ADDENDUM NO. 2

WASHINGTON STATE PARKS AND RECREATION COMMISSION
NISQUALLY STATE PARK
WELCOME CENTER & LOOP TRAIL PHASE 3B
NW-C1218C

DATE: August 26, 2025

C3.4

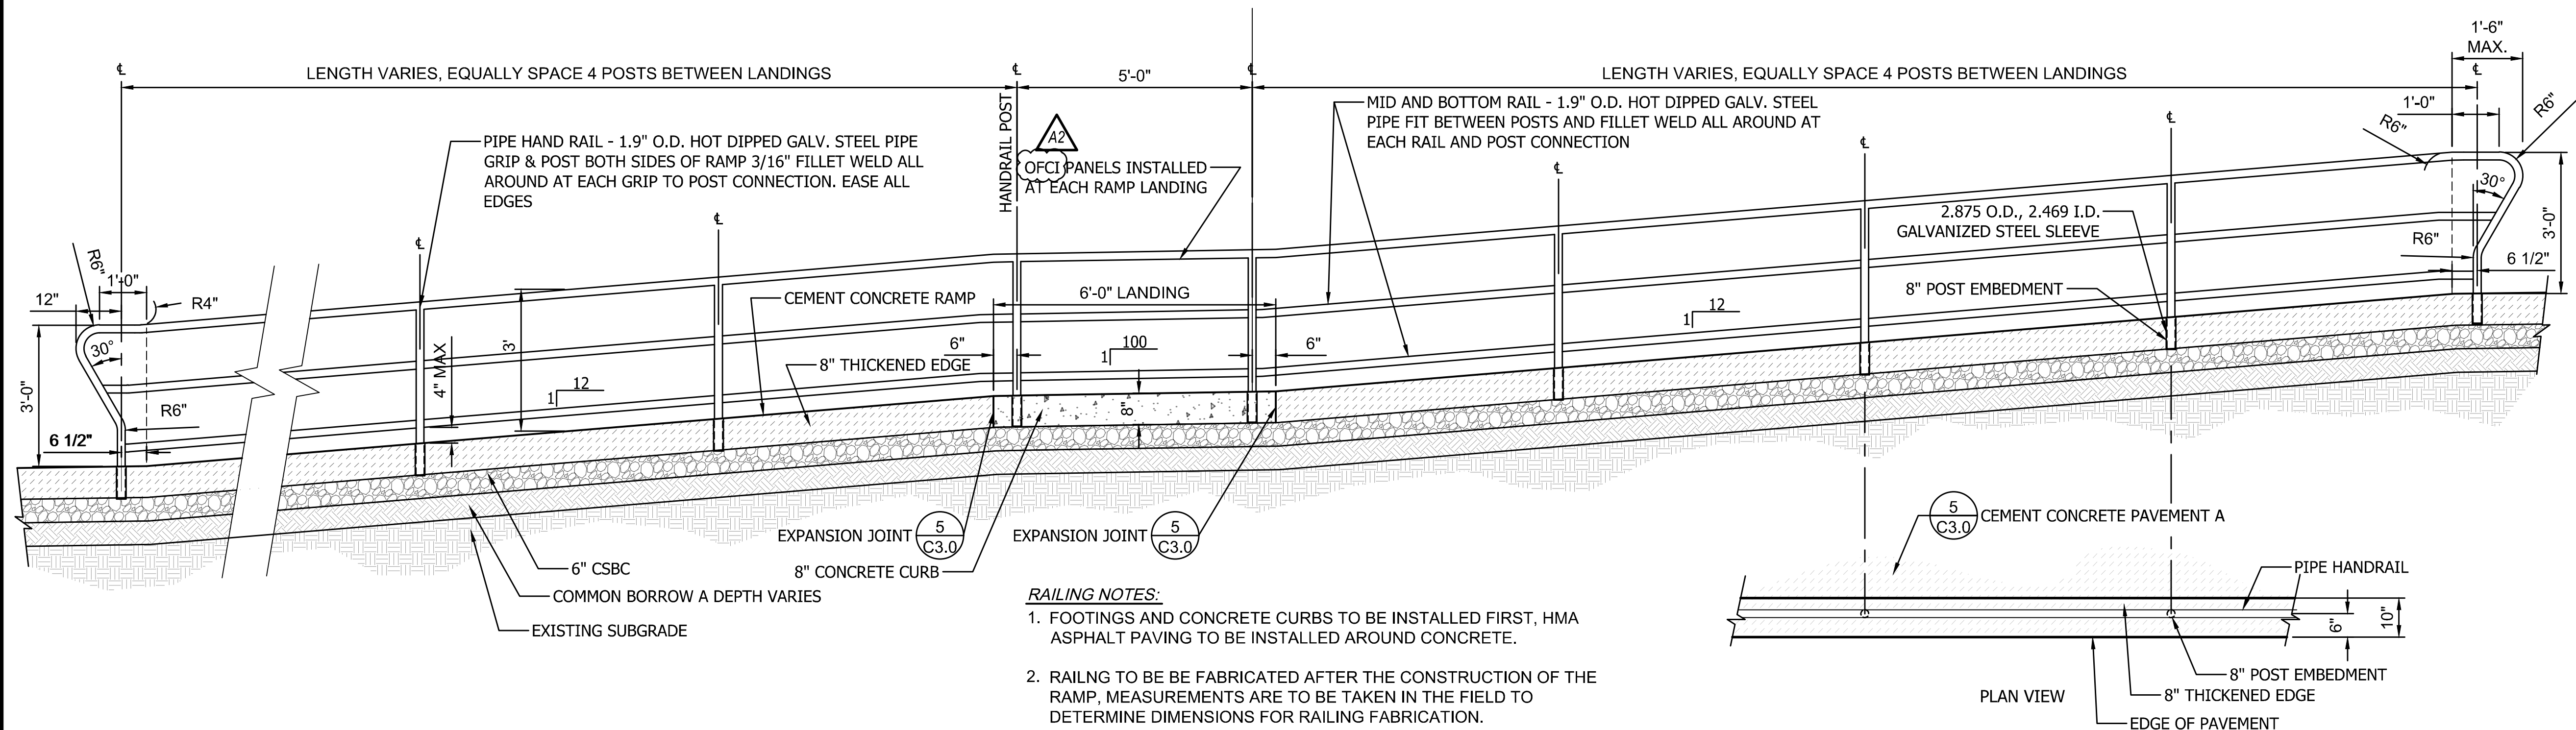
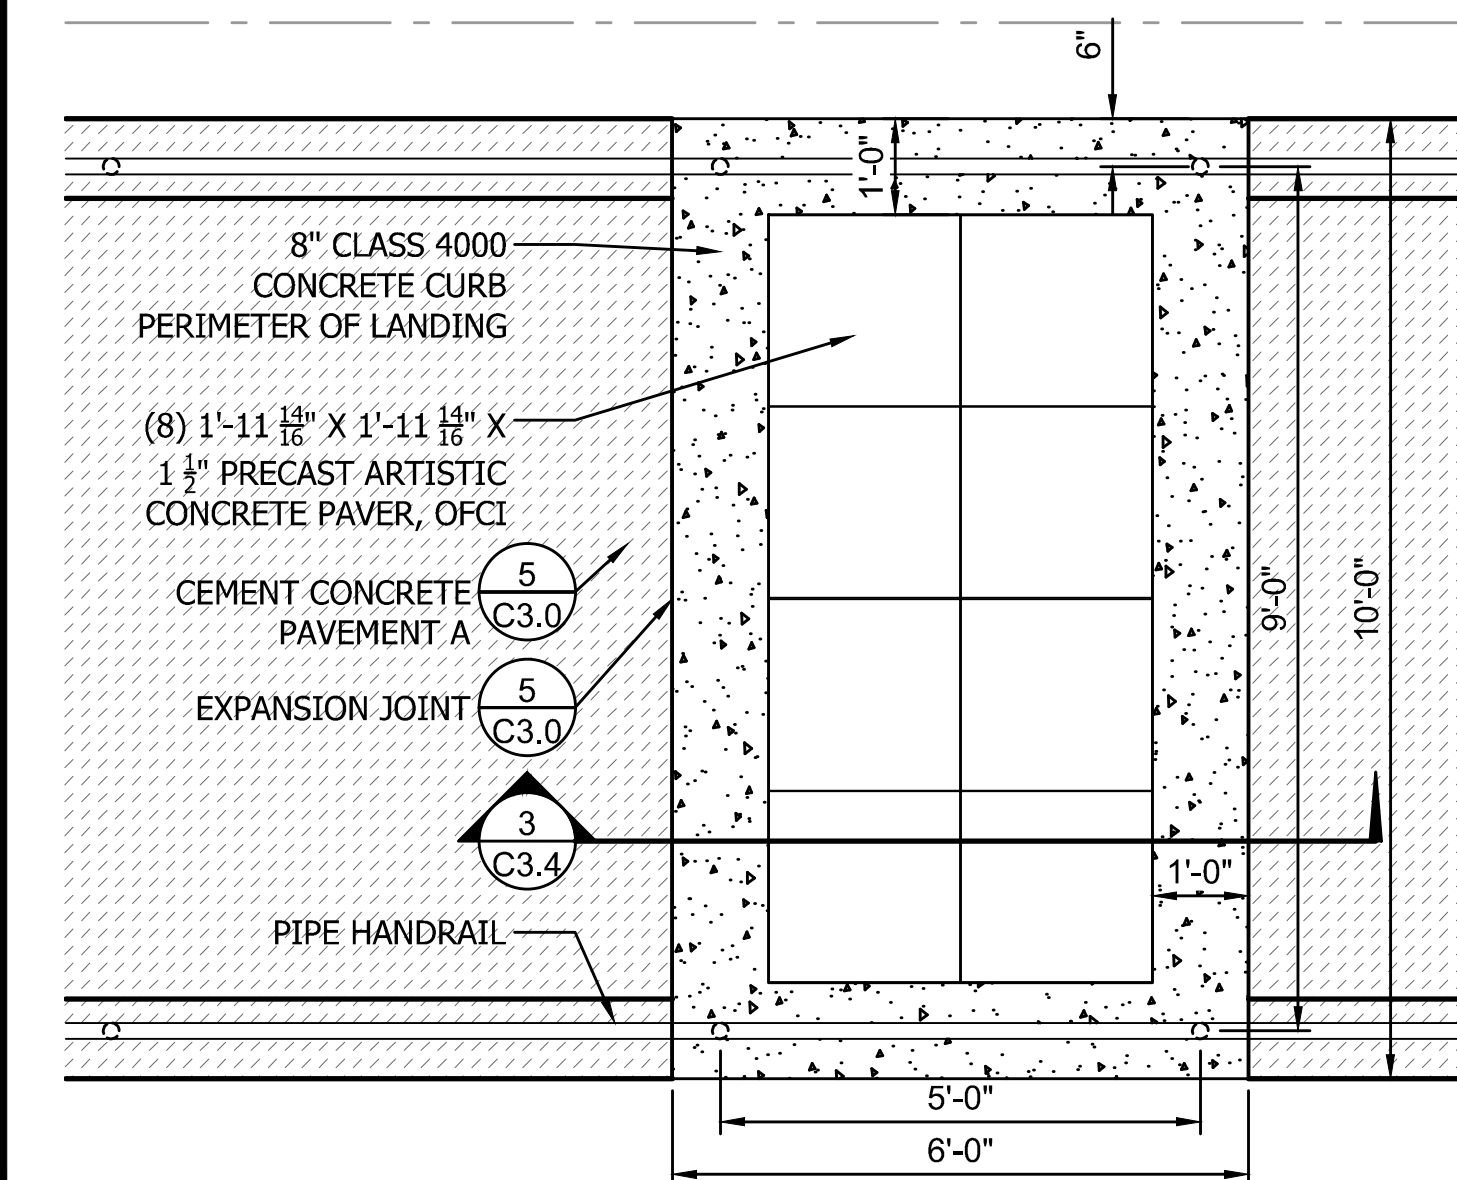
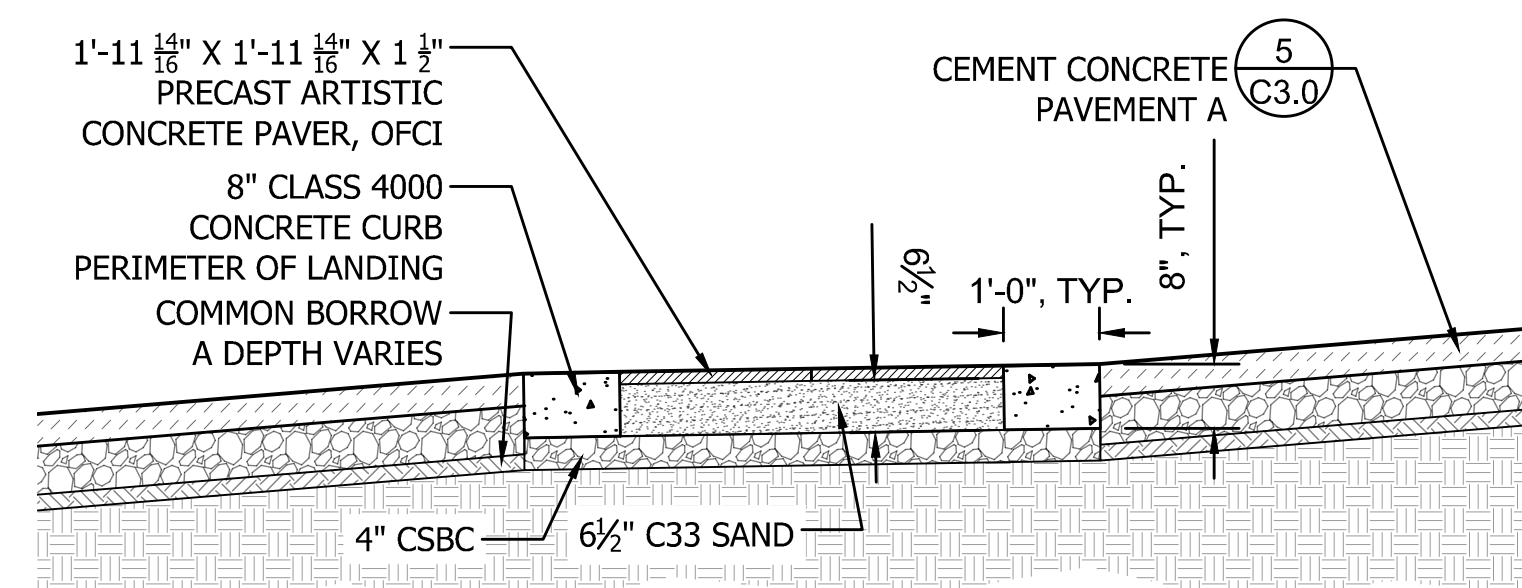
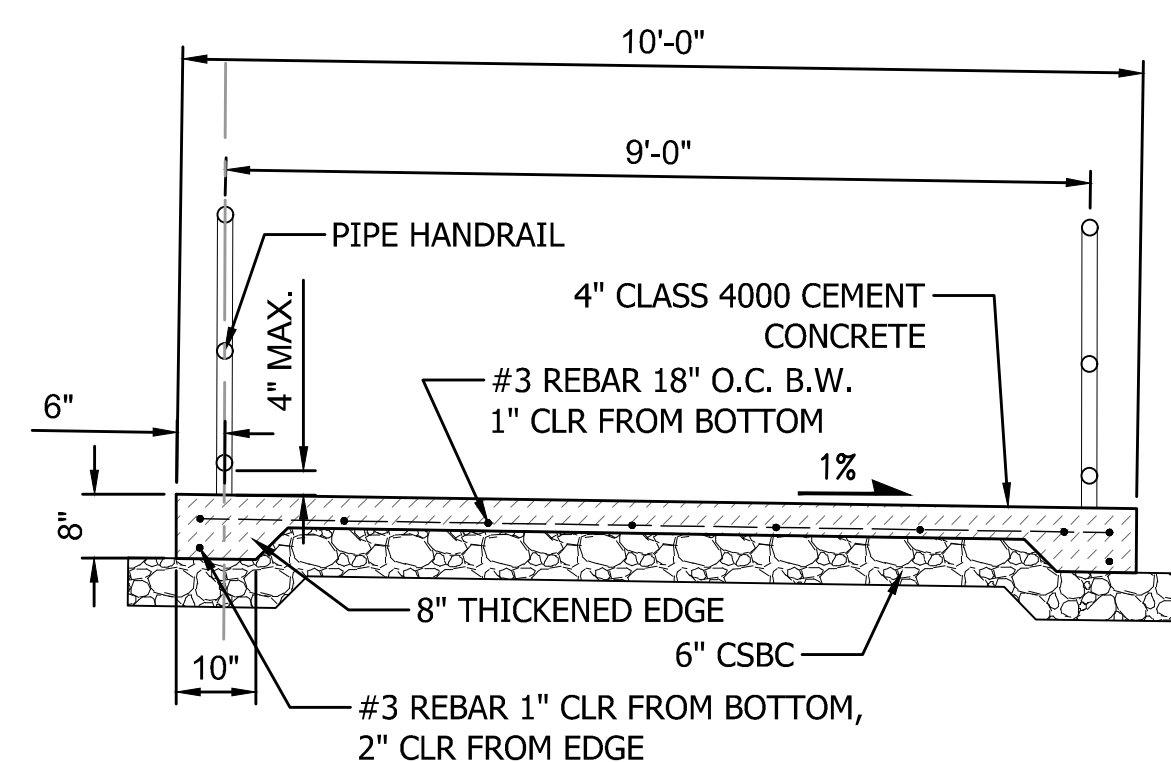
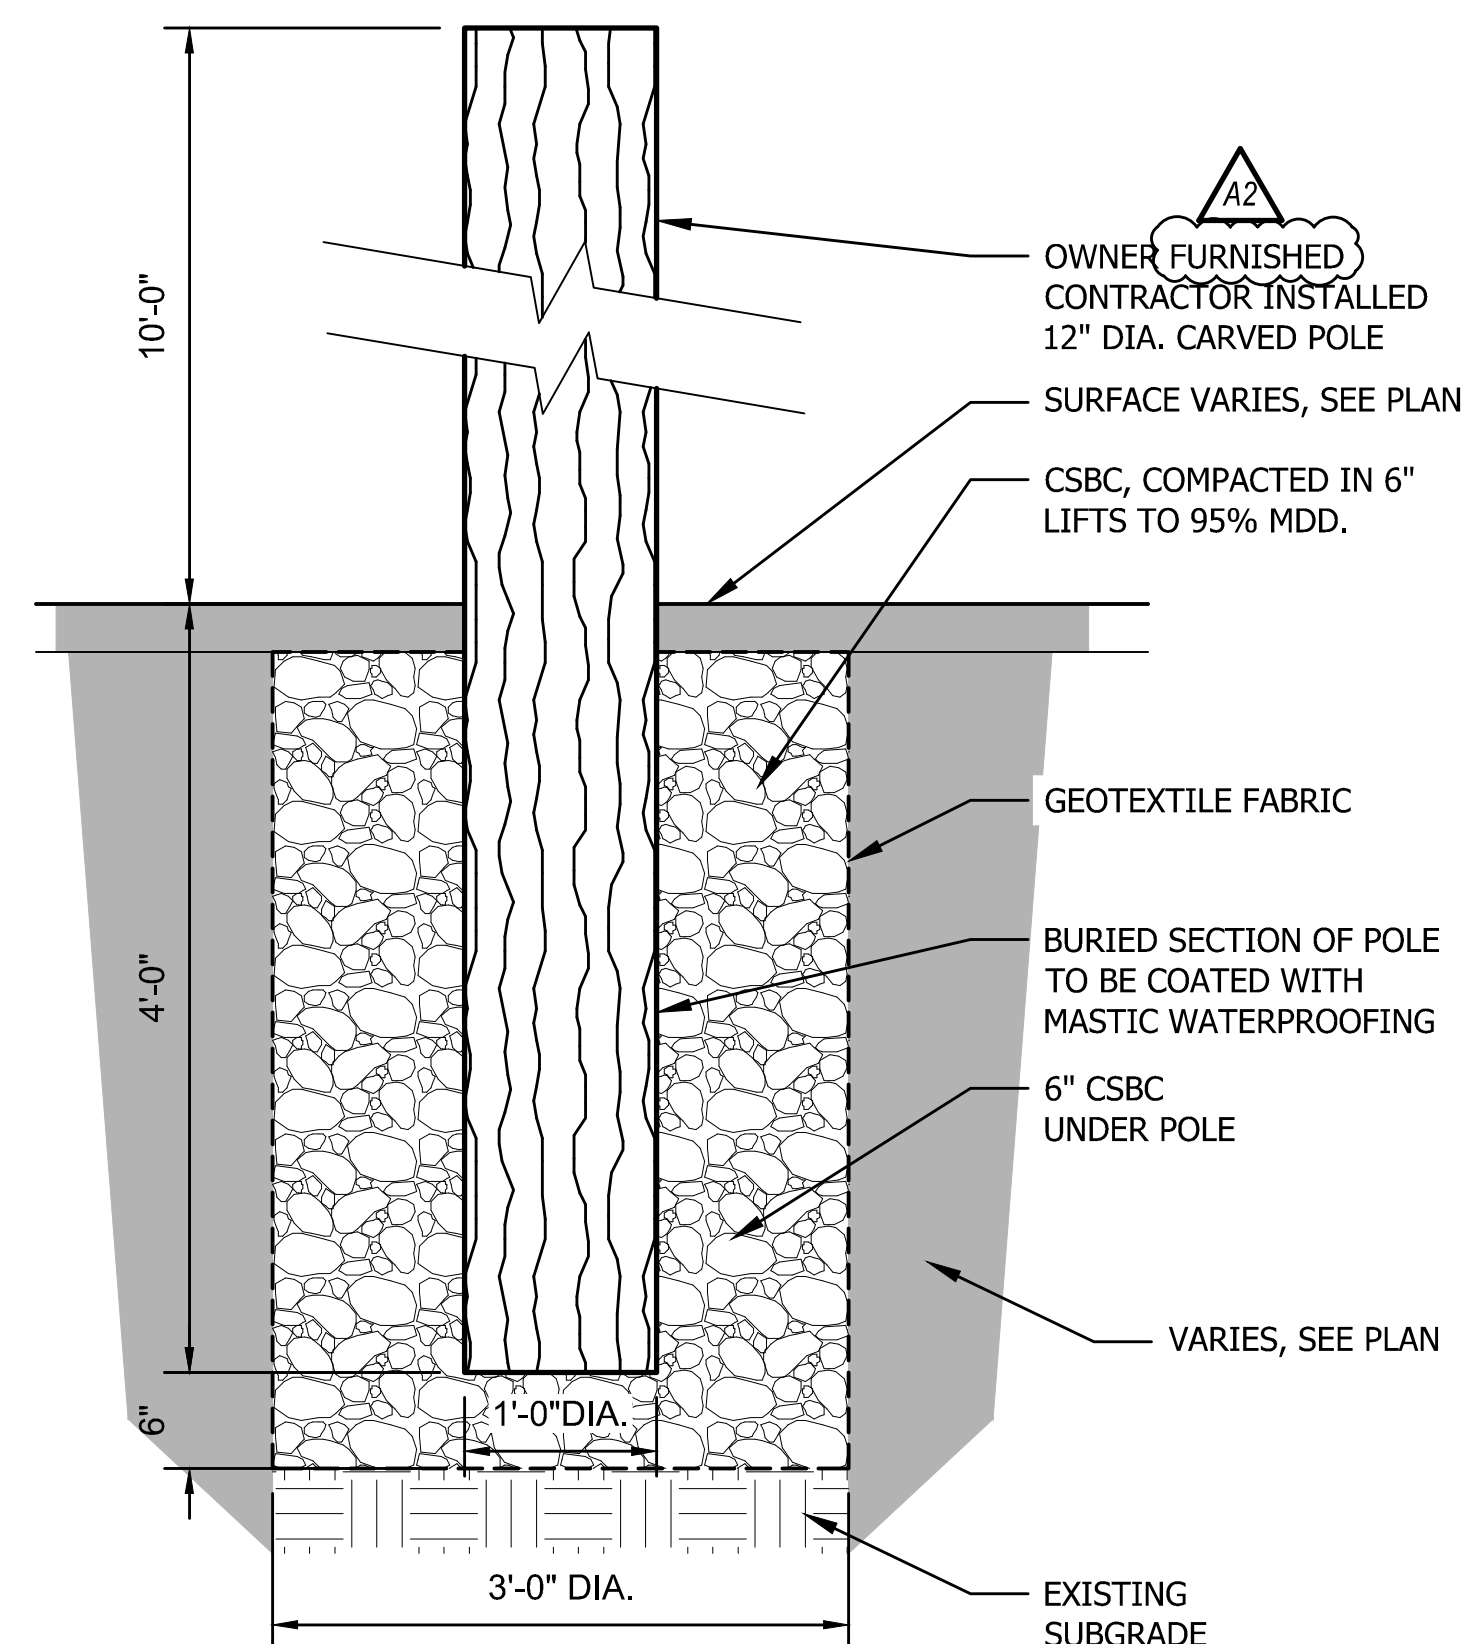
2. Question: Locations? Quantity? start/stop? Cannot locate 'paddle railing' from Owner
Furnished Item Table in section 01600
Answer: Provided on both sides of each landing of the approach ramp as per detail 1/C3.4

4. Question: Please not OFCI on 2/C2.2 for 2 Threshold poles at overlook approach.
Answer: Already noted on detail see 5/C3.4 which callout on C2.2 directs you to.

ADDENDUM #2:
-ADJUST NOTES TO MATCH
SPECIFICATIONS
